QUALITY ASSURANCE -- NON-CONFORMANCE REPORT

Location: Changxing Island, Shanghai, P.R. China**Report No:** NCR-000608**Prime Contractor:** American Bridge/Fluor Enterprises, a JV**Date:** 06-Jan-2010**Submitting Contractor:** Zhenhua Port Machinery Company, Ltd (ZPMC), Changxing Island**NCR #:** ZPMC-0581**Type of problem:**

Reference Description: ZPMC performed Base Metal Repairs without the Engineer's approval in Segment 6AW

Subject: NCR No. ZPMC-0581

Reference Description: ZPMC performed Base Metal Repairs without the Engineer's approval in Segment 6AW

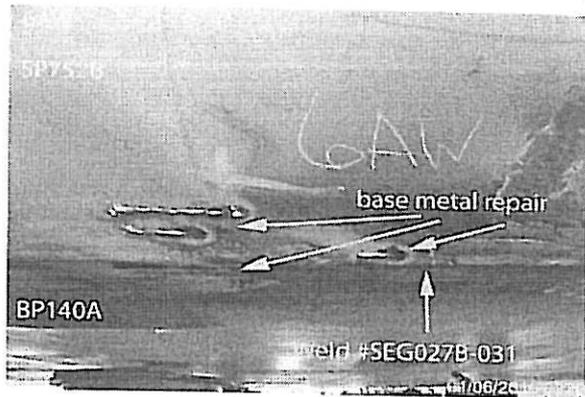
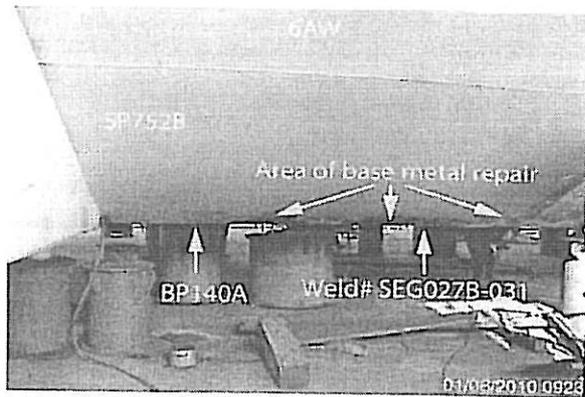
During the Quality Assurance (QA) random in-process visual inspection of the OBG segments in the Trial Assembly area, this QA inspector discovered the following issues:

- Base metal repairs (BMR) were being performed without prior approval of the Engineer at locations of removed temporary attachments.
- These BMR's were located on the east end of the segment on the Bottom Plate (BP140A) and Side Plate (SP752B), Cross Beam side.
- The Bottom Plate is identified as: BP140A
- The Side Plate is identified as: SP572B
- This complete joint penetration (CJP) weld # SEG027B-031 joins panels BP140A to SP752B.
- The approximate lengths of the BMR's range from 10mm to 150mm on BP140A and 30mm to 150mm on SP752B.
- A total of nine (9) repairs were in-process on BP140A and seven (7) repairs on SP752B.
- Theses repairs begin at the 6AW/6BW segment splice progressing west approximately 3100mm.
- The material is A709M Grade 345 SPCM.

Reference Description: ZPMC performed Base Metal Repairs without the prior approval of the Engineer in Segment 6BE/6CE

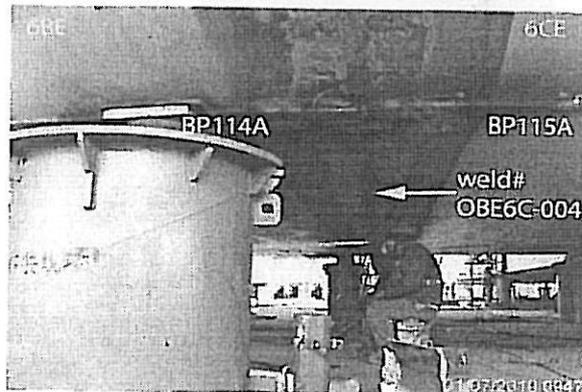
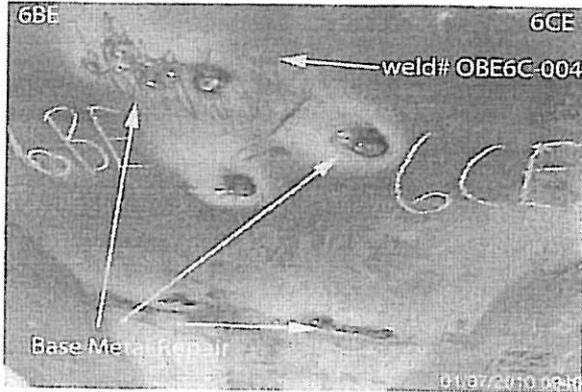
- Base metal repairs (BMR) were being performed without prior approval of the Engineer at locations of removed temporary attachments.
- These BMR's were located along the 6BE/6CE Bottom Plate Complete Joint Penetration (CJP) Splice.
- The Bottom Plates on 6BE are identified as: BP168A, BP60A, BP114A
- The Bottom Plates on 6CE are identified as: BP169A, BP61A, BP115A
- The CJP splice weld # is designated OBE6C-004.
- The approximate lengths of the BMR's range from 10mm to 150mm.
- A total of seventeen (17) repairs were in-process on 6BE and twenty-two (22) repairs on 6CE throughout the length of the Bottom Plate splice.
- The material is A709M Grade 345 Non-SPCM.

- Base metal repairs (BMR) were being performed without prior approval of the Engineer at locations of temporary attachments.
- These BMR's were located along the 6BE+6CE Edge Plate Complete Joint Penetration (CJP) Splice.
- The Edge Plate on 6BE is identified as: EP41A
- The Edge Plate on 6CE is identified as: EP36A.
- The CJP splice weld # is designated OBE6A-005.
- The Approximate lengths of the BMR's range from 15mm to 125mm.
- A total of eleven (11) repairs were in-process on 6BE and four (4) repairs on 6CE throughout the length of the

Description of welding discontinuity:

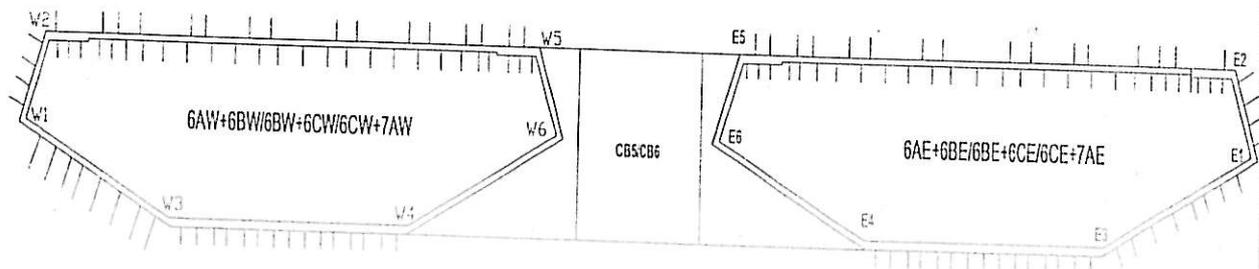
经检查发现西线6AW+6BW/6BW+6CW/6CW+7AW及东线6AE+6BE/6BE+6CE/6CE+7AE吊装段底板、非联系梁侧斜底板及腹板,顶板马板去除后母材需修补。具体位置见下图所示:

After inspection west linear 6AW+6BW/6BW+6CW/6CW+7AW and east linear 6AE+6BE/6BE+6CE/6CE+7AE lifting bottom plate and side plate, edge plate without face strut plate, deck plate, the base metal was gouged after removing temporary attachment, the detail sees the following draft.

1. QC和CWI在整个修补过程中都应在场并指导以确保返修按照处理意见以及AWS D1.5要求进行;
 2. 按照焊接返修工艺规程(WPS)打磨缺陷区域至光滑;
 3. 准备一个正确的接头形式, 具体参见返修的WPS;
 4. 在NDT检测前口头通知QA。对返修区域作100%MT和100%VT检查;
 5. 如果仍发现有缺陷, 通过打磨的方法去除所有缺陷以确认缺陷完全被消除, 并重复第四步以确认缺陷完全被消除;

6. 将杂物以及MT检测遗留的残留物清理干净;
 7. 根据批准的焊接返修工艺规程(WPS)进行预热及焊接;
 8. 将焊接区域打磨至与母材平齐;
 9. 在NDT检测前口头通知QA。对返修区域作100%MT和100%VT检查。
-
1. QC and CWI should be present to witness the repair, direct and supervise all repair operations during this repair to ensure the repair is per the disposition requirements, and the AWS D1.5 code requirements.

2. Grind the repair area to a smooth finish according to the approved repair WPS.
 3. Prepare the joint according to the approved WPS.
 4. Notify QA verbally prior to NDT. Perform 100%MT and 100%VT of the repair area.

5. Remove all defects by grinding to ensure all defects are completely removed if defects still exist, and repeat "step 4" to assure complete removal of all defects if necessary.

6. Clean the repair area of all loose debris including MT powder.
 7. Preheat and weld according to the approved WPS.
 8. Grind the weld flush after welding.

9. Notify QA verbally prior NDT. Perform 100%MT and 100%VT of the repair area.
